ENGINE - DIFFUSER AND COMBUSTOR GROUP - PROVIDE A NEW BRACKET ASSEMBLY WHICH HAS
ADDITIONAL SUPPORT FOR THE FIRE DETECTION RAIL - CATEGORY CODE 3 - MOD.ENG-72-0206

V2500-ENG-72-0206

SERVICE BULLETIN

Fig.1

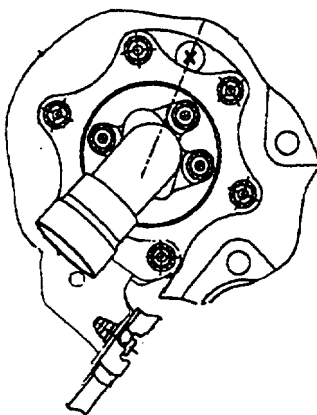
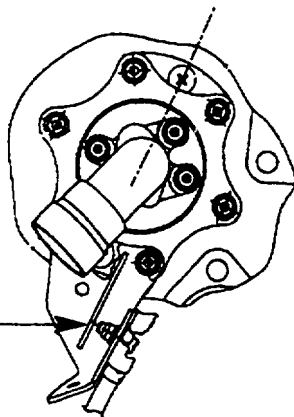
THE NEW BRACKET
ASSEMBLY HAS A
REINFORCING RIB

Before and after views of configuration changes that affect the loop clamp bracket assembly that supports the fire seal

- (1) The Loop Clamp Bracket that supports the No. 4 bearing tube and the the fire detection rail is replaced with a Loop Clamp Bracket Assembly. This Loop Clamp Bracket Assembly has a reinforcing rail and provides added support for the fire detection rail.

Location of the Loop Clamp Bracket Assembly
Fig.2

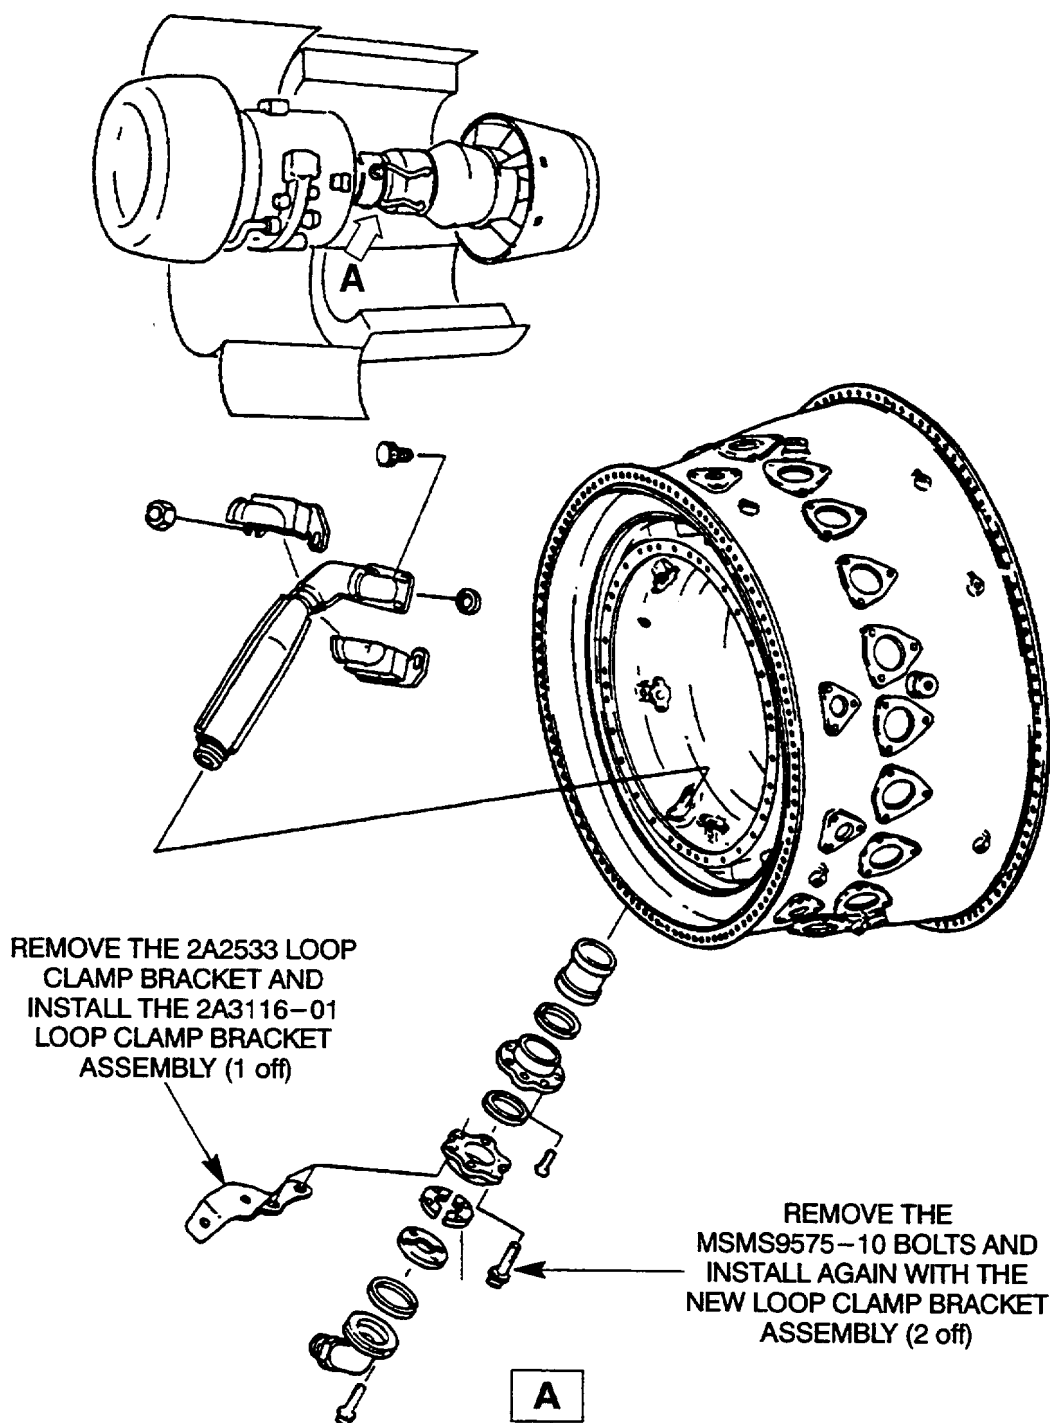
- (1) Gain access to the 2A2533 Loop Clamp Bracket. Refer to Figure 1.
- (2) Remove the wire that safeties the bolts, which hold the No. 4 Bearing Sealing Sleeve in position.
- (3) Disconnect the nut and bolt that holds the loop clamp on the fuel manifold to the Loop Clamp Bracket.
- (4) Disconnect the nut and bolt that holds the loop clamp on the No. 4 Bearing Oil Scavenge Tube to the Loop Clamp Bracket.
- (5) Remove the bolts (2 off) that hold the Loop Clamp Bracket to the sealing sleeve.

Modification to incorporate the new Loop Clamp Bracket Assembly
Fig.3

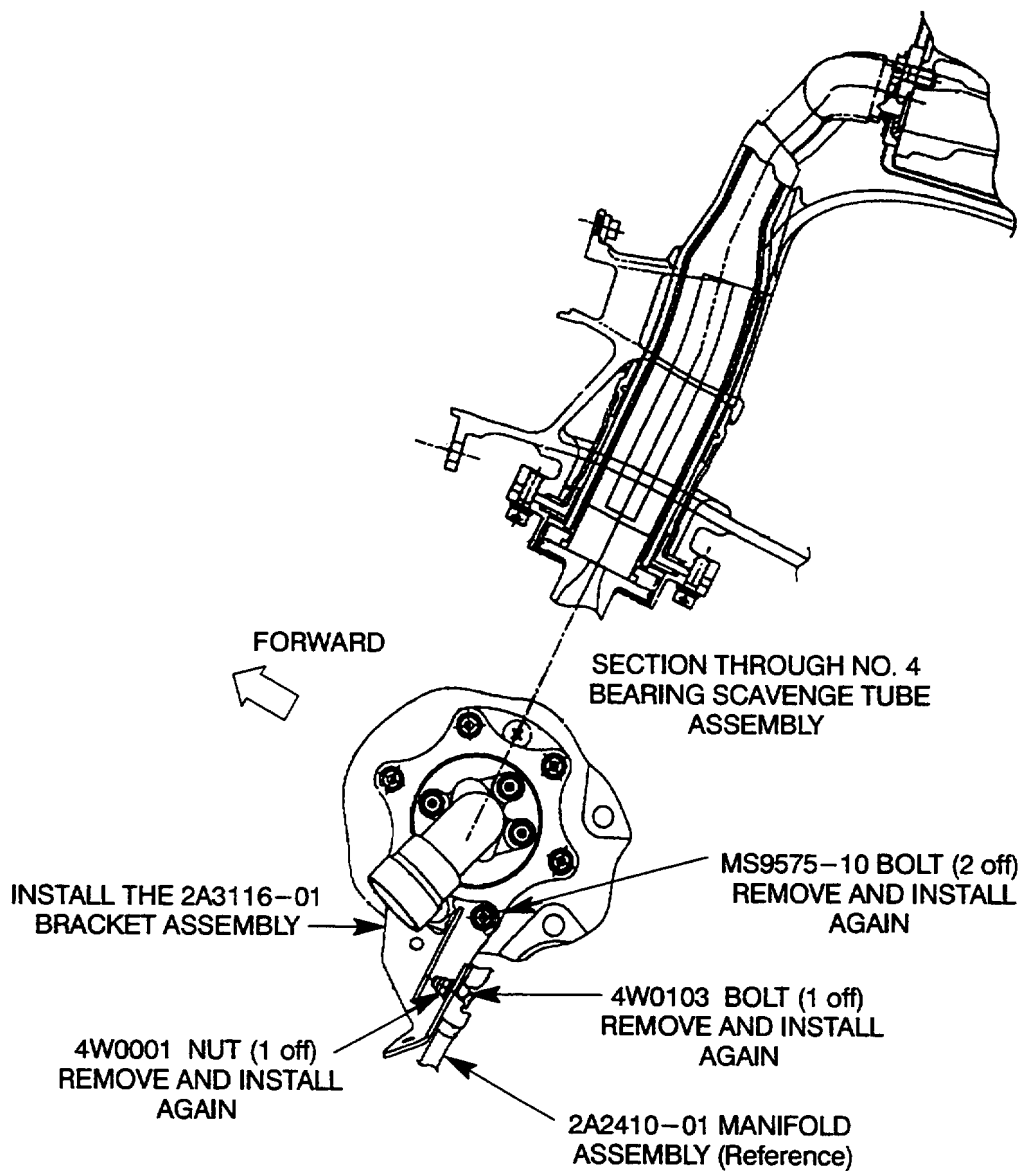
- (1) Lubricate the MS9575-10 Bolts (2 off) with CoMat 10-077 Approved Engine Oil.
- (2) Put the 2A3116-01 Loop Clamp Bracket Assembly (1 off) in position on the sealing sleeve.
 - (a) Align the two bolt holes in the bracket assembly with the two open holes in the sealing sleeve.
 - (b) Hold the loop clamp bracket assembly in position with your hand.
- (3) Install the MS9575-10 Bolts (2 off) with your hand and tighten them with your fingers.
- (4) Torque the bolts to 75 to 85 lbfin (8,474 to 9,604 Nm). See Reference (3), 70-41-00, Torque Tightening Technique.
